# UNITED STATES PATENT AND TRADEMARK OFFICE

APPLICATION NO.	FILING DA	TE	FIRST NAMED INVENTOR	ATTORNEY DOCKET NO.	CONFIRMATION NO.
10/752,398	01/05/2004		Christopher N. Gab	3172 PUS	3585
75	90 10	0/13/2006		EXAMINER	
Konstantine J. Diamond 4010 E. 26th Street			AYRES, TIMOTHY MICHAEL		
Los Angeles, CA 90023				ART UNIT	PAPER NUMBER
				3637

### **DETAILED ACTION**

Breezer '434 Figure 6

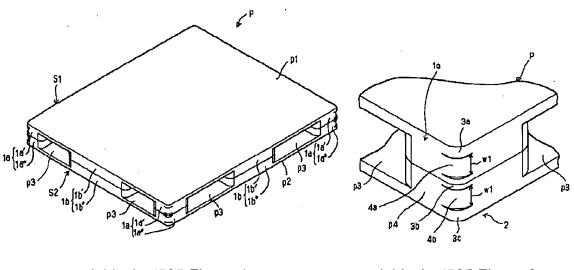
1. Claims 1-3 and 5-18 are rejected under 35 U.S.C. 103(a) as being unpatentable over US Patent 5,046,434 to Breezer in view of Japanese Patent 2001-270,525 to Ishizuka Glass. Breezer 'teaches a pallet (20) with a deck (22) formed from an upper panel (24) and a lower panel (26). The upper panel (22) makes up an upper surface and has a plurality of openings (50). The lower panel (26) extends the plurality of supports (38) as seen in figure 6 below so that each support (38) aligns with an opening (50) (Col. 3, line 37-39). The pallet (20) is a nestable pallet (Col. 3, line 42-52). A projection (A') extends outwardly from the edges (B') of the deck (22). The corners (40) of the pallet (20) are rounded as seen in figure 1.

2. Breezer does not expressly disclose the projection not being continuous about a periphery of the deck, the upper surface of the projection flush with the upper surface of the deck, and the projection not extending past the side edges or past the end edges.

Ishizuka '525 Figure 3

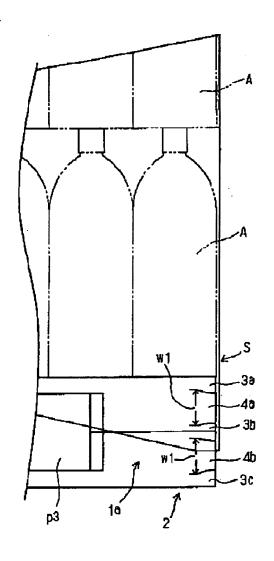
4. The upper surface of the projection (3a) is flush with the upper surface (p1) of the deck as seen in figure 4. The plurality of goods (A) on the upper surface (p1) is wrapped with a wrap (S) to at least partially go around an edge adjacent to the projection (3a) as seen in figures 3 and 5. The projection (3a) does not extend outwardly past the side edges or past the end edges as seen in figure 3.
